11 June 2020
Our Ref: 20414C.1AJC_VIA addendum

**RE: ADDENDUM TO VISUAL IMPACT ASSESSMENT
PROPOSED ALTERATIONS AND ADDITIONS
DAPTO PUBLIC SCHOOL
66 SIERRA DRIVE, HORSLEY**

Figure 4 Roof Profile Option 1 – Section through Block I

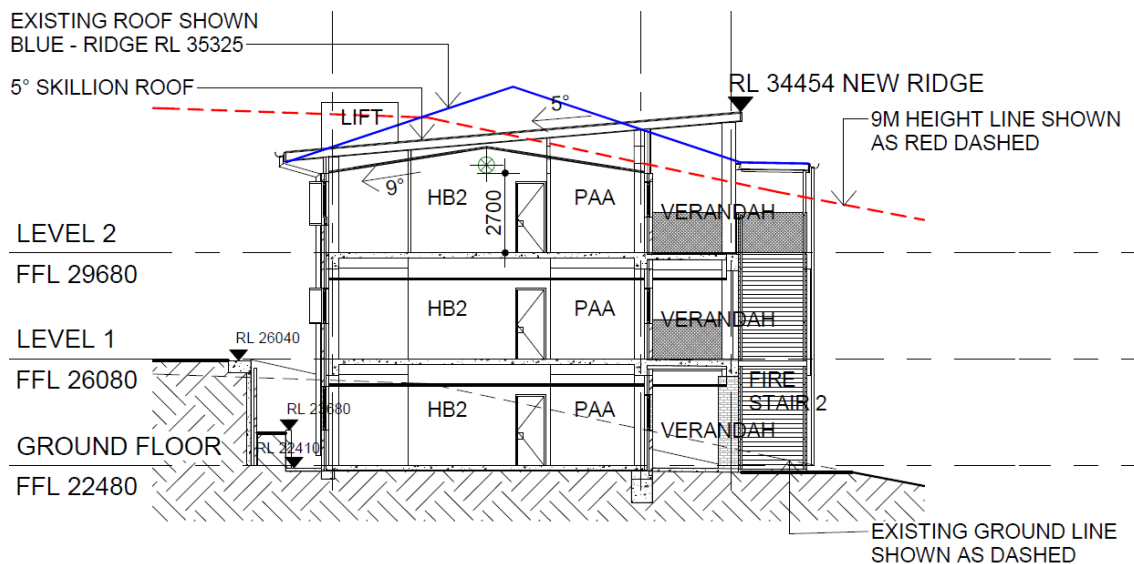
- Option 1: Skillion roof with 5 degree roof pitch (**Figure 4**);
- Option 2: Hip roof with 18 degree roof pitch (**Figure 5**); and
- Option 3: Gable roof with 5 degree roof pitch (**Figure 6**).

In each of these figures, the blue line represents the profile of the roof based on the February 2020 design amendment and the red line represents the height 9m above existing ground level which is the building height development standard that applies to the site under Wollongong Local Environmental Plan 2009 (WLEP 2009).

Figure 6 Roof Profile Option 3 – Section through Block I

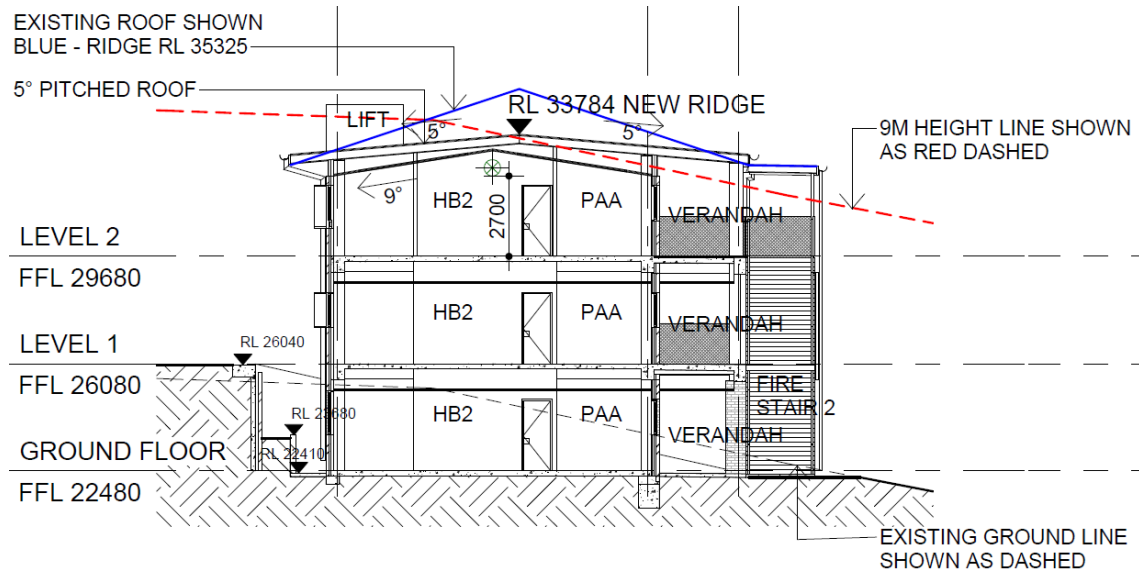
The preferred option is roof profile option 3 as it reduced the maximum height of the Block I by more than 1.5m. Following discussions with the applicant and School Infrastructure NSW (SINSW), further design amendments to the roof profile were made including changing the roof of both Blocks H and I to a hip roof.

Figure 7 Preferred Roof Profile Option 3 with ridge at RL 33.765. The dashed red-line shows the 9m building height limit.

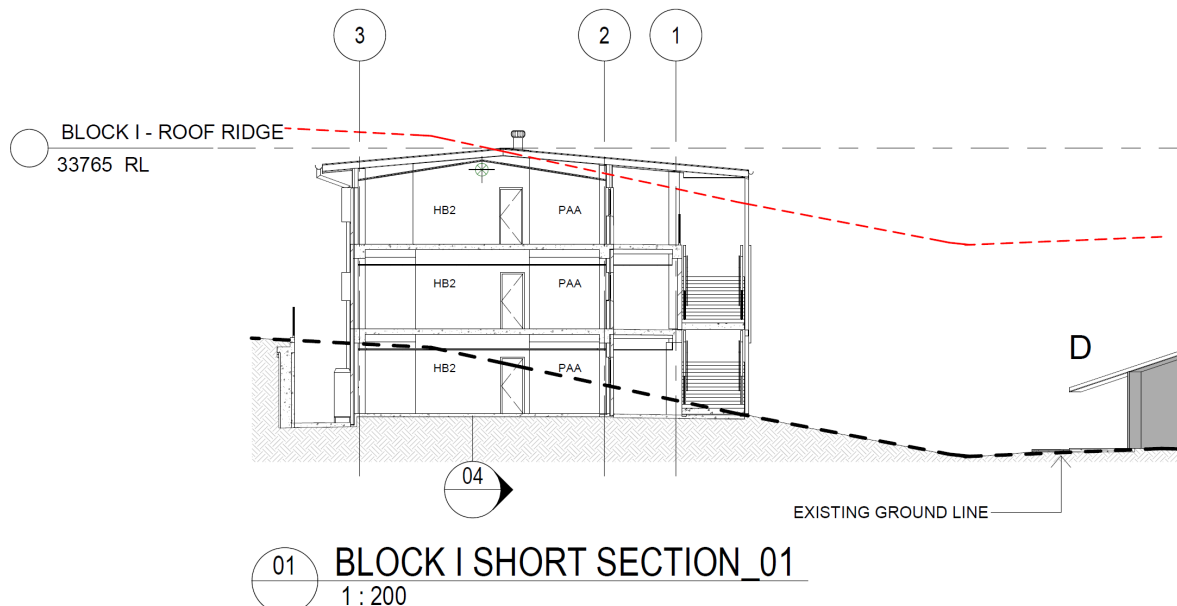
The ridge height of the new roof profile is RL 33.765, which is 1.56m lower than the RL of the ridge height of the amended DA (February 2020) - refer **Figure 7**.
